PROJECT : INSPIRE BKC

Inspection Report Prepared by:
Pankaj Ghare (Landscape Wall Systems) 9819663630

INSPECTION -1

INSPECTION -2

Broken Glass

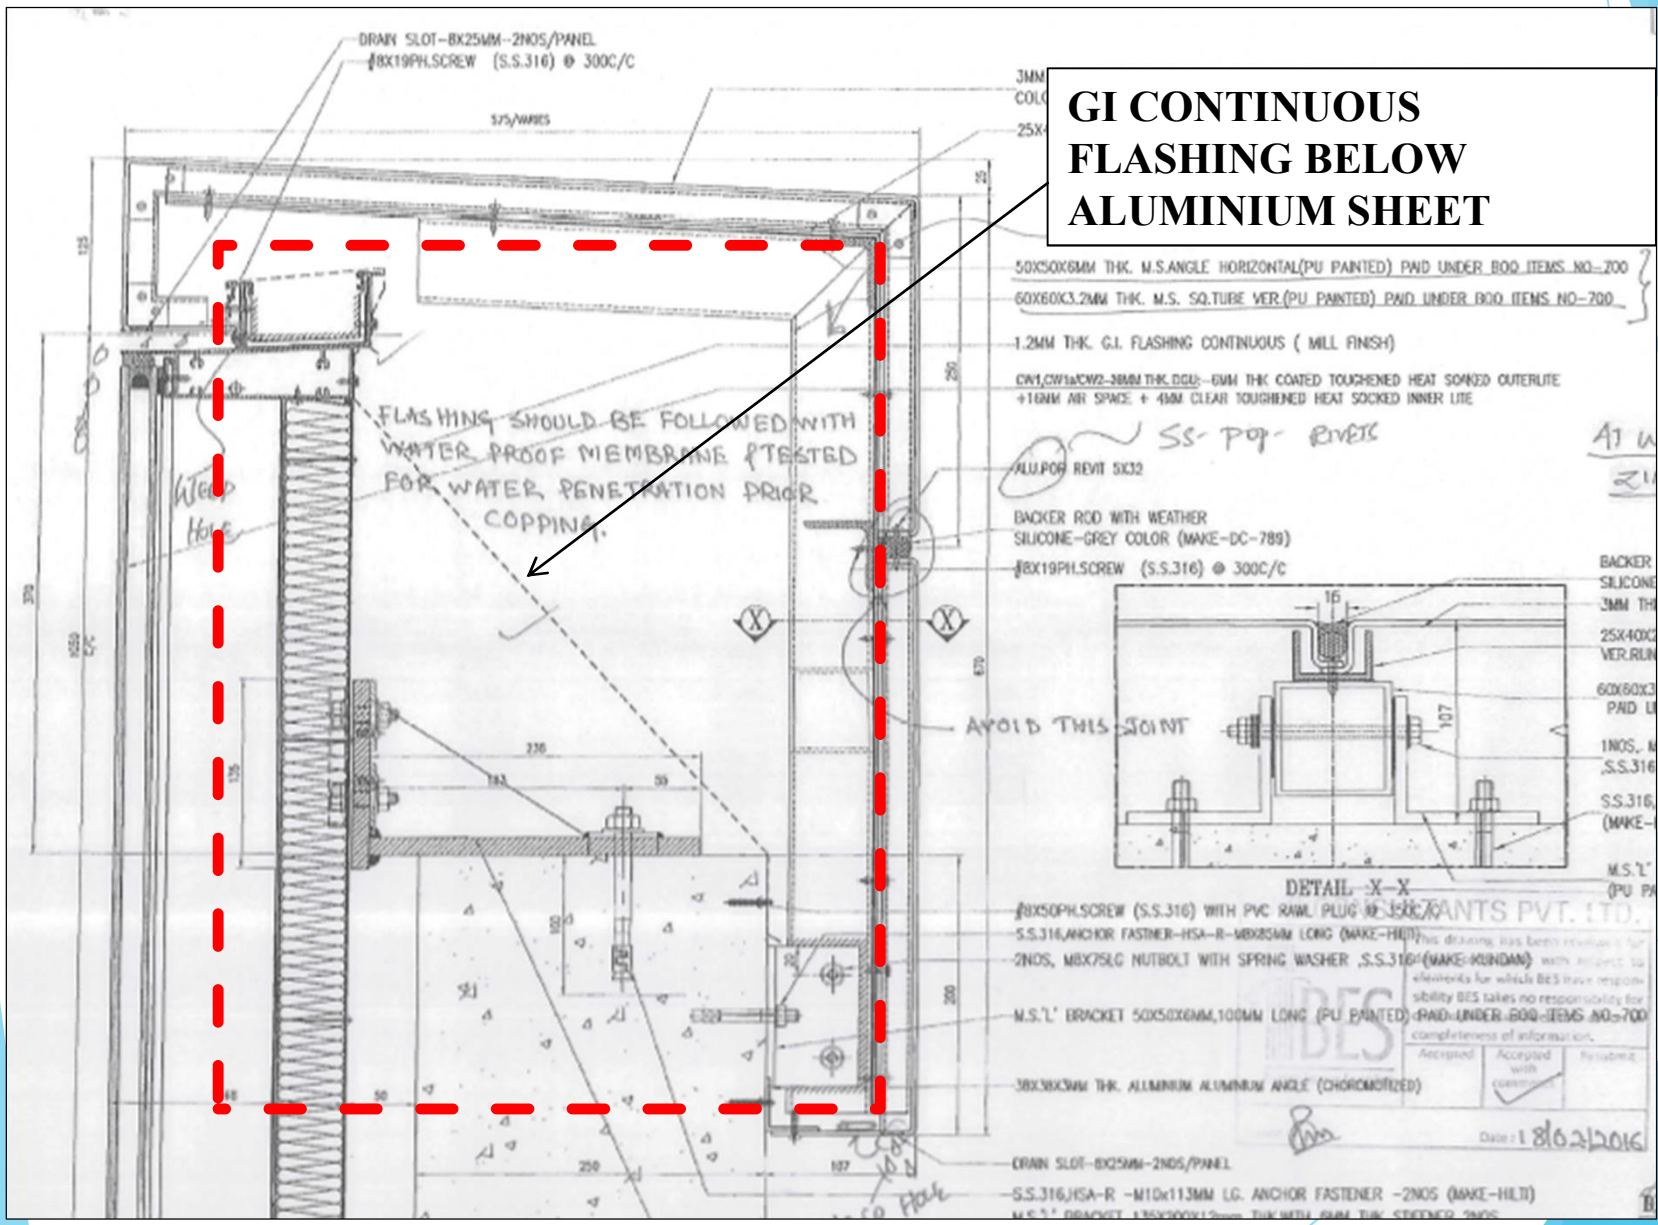
Floor :3rd Floor ; Panel for which shifting is done.

Broken Glass is replaced with New DGU.
